WOLF CREEK NUCLEAR OPERATING CORPORATION

ET 10-0005

Subject: Docket No. 50-482: Response to Request for Additional Information Related to License Amendment Request for Deviation from Fire Protection Program Requirements

REQUEST FOR ADDITIONAL INFORMATION
DEVIATION FROM FIRE PROTECTION PROGRAM REQUIREMENTS
WOLF CREEK NUCLEAR OPERATING CORPORATION
WOLF CREEK GENERATING STATION
DOCKET NO. 50-482

FPPM-012 ISSUE 0
 CONTROL RM COMM. COR
 BLDG EL. 2047'-6"
 AP-10-026 SCALE - NONE

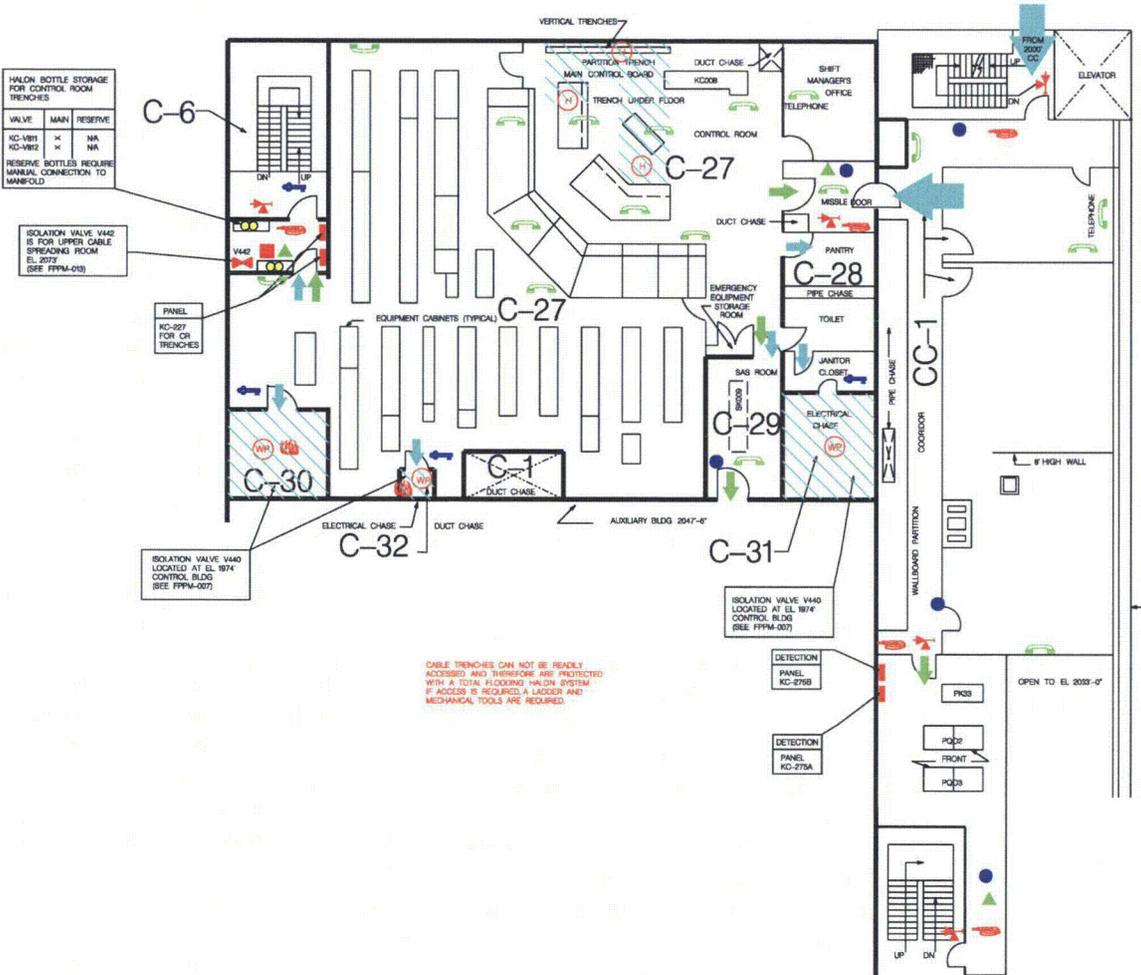
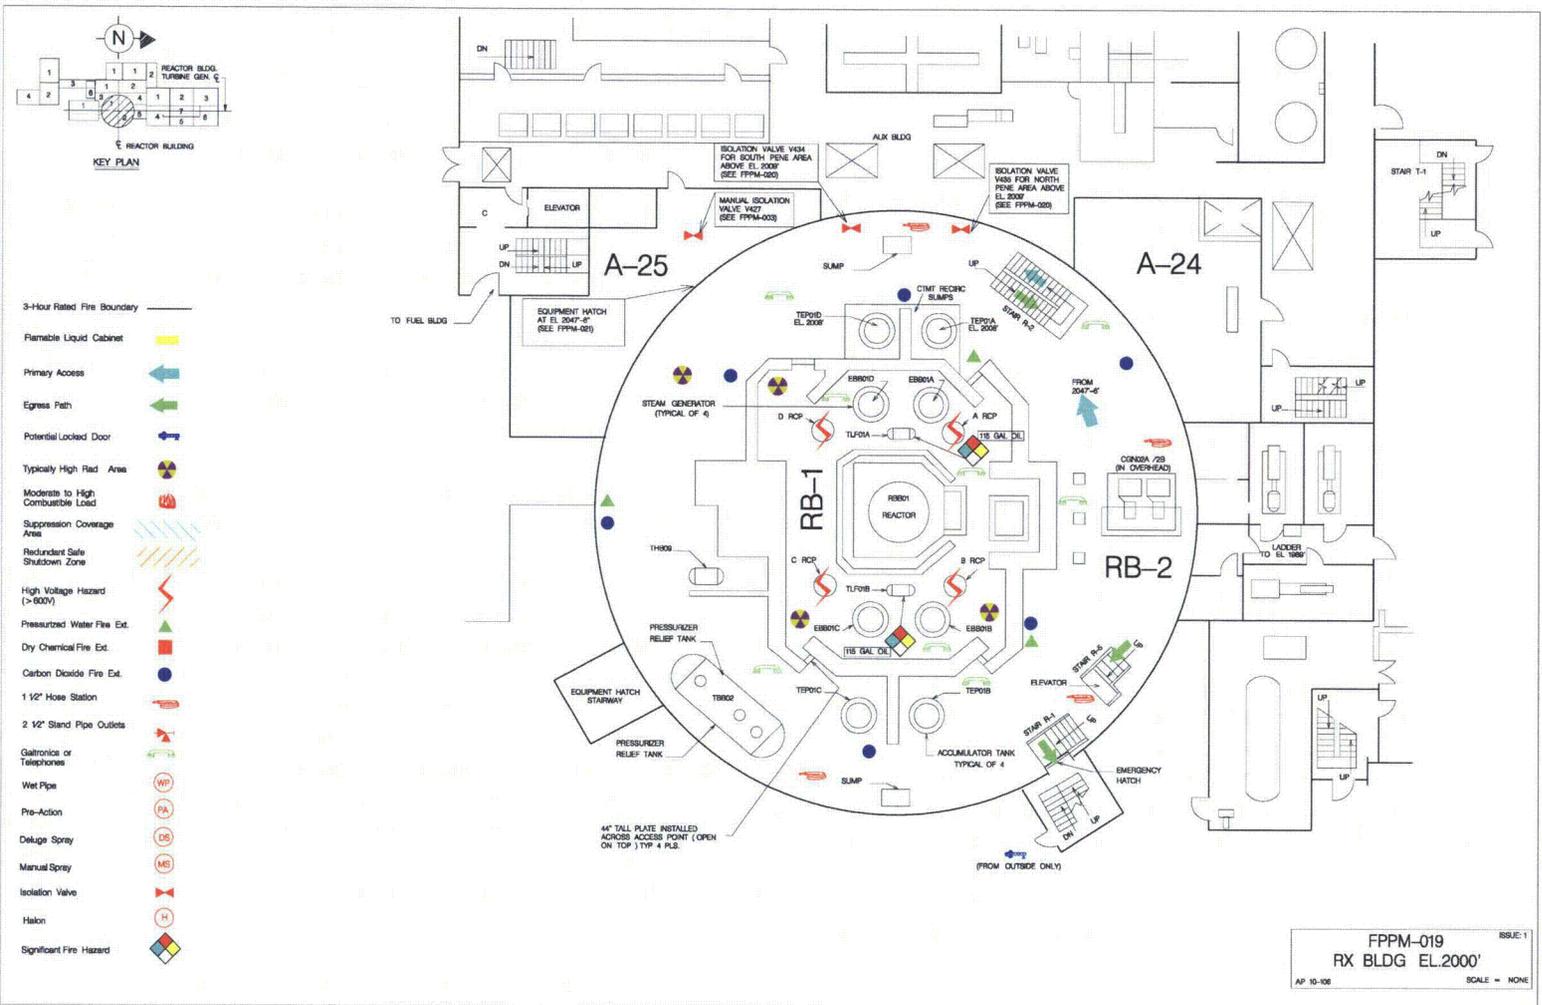
RAI-04.1: Please provide critical details or assumptions regarding the *in-situ* and transient fire hazards that could threaten redundant equipment for each fire area included in the requests. This information may include, but is not limited to:

- The number, type, and location of potential ignition sources,
- The number and types of equipment that may exhibit high-energy arcing faults, and the relationship between this equipment and any secondary combustibles,
- The quantity of cables and other secondary combustibles and their relationship to potential ignition sources,
- The cable type (e.g., thermoplastic or thermoset); if thermoplastic cables are used, please provide a discussion of self-ignited cable fires,
- Ratings for cables (e.g., Institute of Electrical and Electronics Engineers (IEEE) 383, etc.); if not rated, please justify why fire spread would be assumed to be slow,

Section 8.X.1 of WIP-E-1F9900-004-A-1 was revised for each fire area to identify approximate room dimensions. Room height is also identified in Attachment B1 of WIP-E-1F9900-004-A-1. Attachment D was added to WIP-E-1F9900-004-A-1, to provide a general plan view for each fire area.
